# UNITED STATES PATENT AND TRADEMARK OFFICE

| APPLICATION NO.   | FILING DATE | FIRST NAMED INVENTOR           | ATTORNEY DOCKET NO. | CONFIRMATION NO. |
|---|-------------|--------------------------------|---------------------|------------------|
| 09/936,404  | 09/11/2001  | Georg Rudolf Theobald Bechmann | CM2069              | 3837             |

| <b>Office Action Summary</b> | Application No.               | Applicant(s)     |

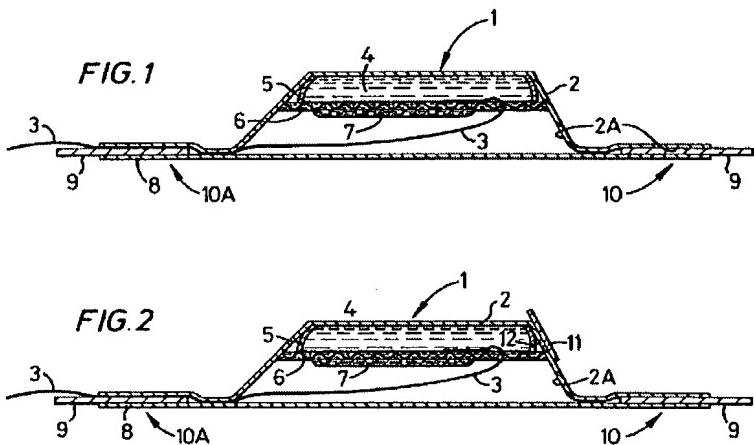
The W'831 publication teaches in Figures 1-2, a bandage 1 provided with a gas impermeably flexible material 2 which is a plastic material such as polyethylene or polyalkylene sheet (page 5, lines 30-35). The sheet material is formed over the entirety of the lower surface with first adhesive layer 2A whereas the upper layer is non-adhesives (page 6, lines 1-6). It is disclosed that centrally disposed on the underside of the sheet material is a chemical material

such as hydrogen peroxide (4) (*the active composition*) (page 6, lines 9-15). Integral with the reservoir material 5 there is a release means 3, preferably a strong string, being its first end detachably attached to the reservoir material along a line of weakness such that when the string is pulled, the reservoir material tears to release the material 4 (*the burstable cell*) (page 6, lines 30-36/page 9, lines 26-37).

It is further disclosed that the enclosed device has the following enclosed volume dimensions: 5 cm by 2cm by 1 cm (COL 10, lines 1-10). It is also evident from **Figures 1-2** above that the internal volume of bandage structure is partly filled, for instance, reservoir 5 enclosing the hydrogen peroxide occupies, at least, half of the bandage structure maximum fillable volume.

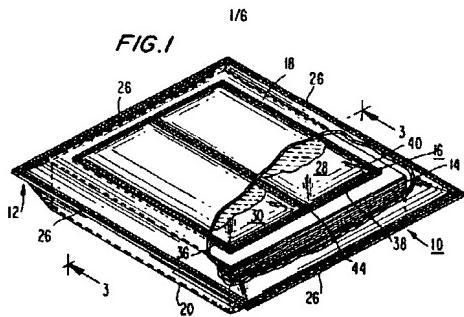
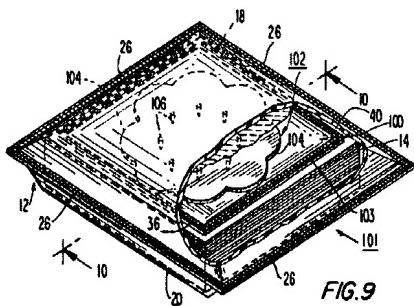
The WO'262 publication disclose a cleaning kit 101 wherein a stack of wipers 14 is packaged together with a container 100 of cleaning fluid (*the active composition*) in a liquid tight outer container 18 (ABSTRACT). Fluid is released from the inner container 100 into the wipers. In one embodiment, fluid is released from the inner container 100 by means of a puncturing

device 102 operable to puncture one of walls of the inner container 100 by application of pressure in a limited area on the outside of the outer container 18 (ABSTRACT). It is disclosed that the container can be resealed to protect its content after the package has been opened (ABSTRACT).

It is disclosed that the container is formed by a first sheet 18 forming a bottom panel on one side, and a second sheet 20 forming a top panel on the opposite side (page 9, lines 23-28). The sheets 18 and 20 are made of plastic and are adhered together along a seam 26 to form an air tight and liquid tight container (page 9, line 28 to page 10, line 3/ page 15, lines 19-24). Thus, the two sheets are sealed together along its edges (page 10, lines 25-29).

It is further disclosed that each bag is burst relatively easily by the application of pressure (page 12, lines 5-13, 15-18 and 20-25) and each has a weakened area (page 11, line 4-10/ page 15, lines 9-15).

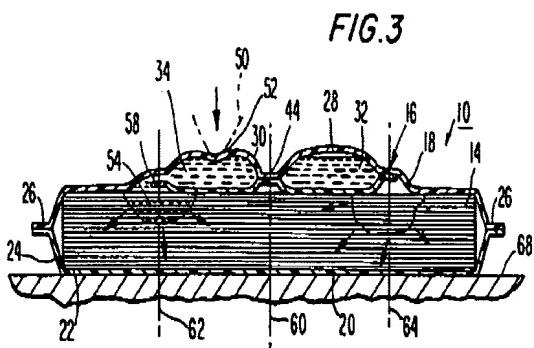
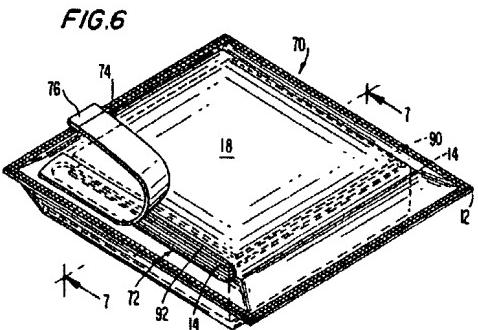
Figures 3 (above) and 10 show a container having a channel shape comprising two sections.

It is also apparent from **Figures 1, 3, 6 and 9** above that the internal volume of container is partly filled, for instance, container 18 has wipers 14 occupying, at least, more than half of the maximum fillable volume.

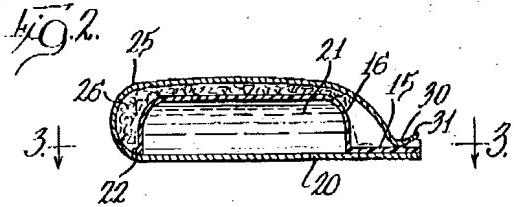
Bailey discloses a self-contained medication applicator with an encapsulated medicine or other fluid (*the active composition*) wherein a rigid section of material is provided with a recess to hold the fluid and a flexible strip has one part thereof sealed to the rigid material to close off the recess and encapsulate the liquid, with an adjacent length of flexible material secured thereto and with a further length of the flexible material peelably attached to the rigid material (ABSTRACT/COL 2, lines 49-63). It is disclosed that the discharge of the fluid is facilitated by having a fractureable seal at one end of the recess (ABSTRACT/ COL 2, lines 49-63).
